Technical Service Bulletin

SUBJECT: Functional issue with emergency stop button (Design B). When pressed, the button may not remain engaged in the lock- out position as designed. In this condition, the switch will still disable machine when pressed, but the button must be held for one to two seconds on some models such as the T5, T7 and R14.

Emergency Stop Button (Design B)

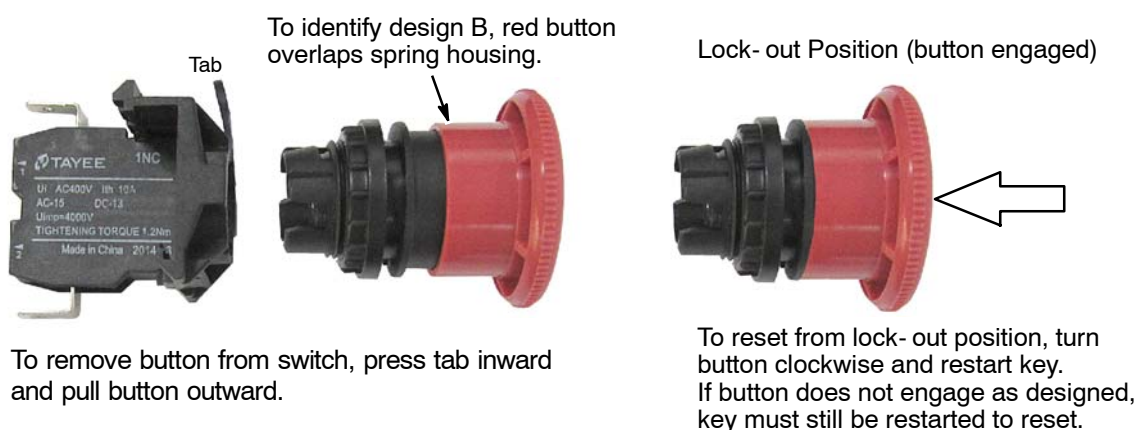
PURPOSE: For machines equipped with emergency stop button (Design B), it's recommended to replace with emergency stop button (Design A) p/n 1011735.

Replace with Emergency Stop Button, p/n 1011735 (Design A)

Note: Both emergency stop button designs share the same part number, confirm correct design before installing. Emergency stop button (Design B) has been removed from inventory.
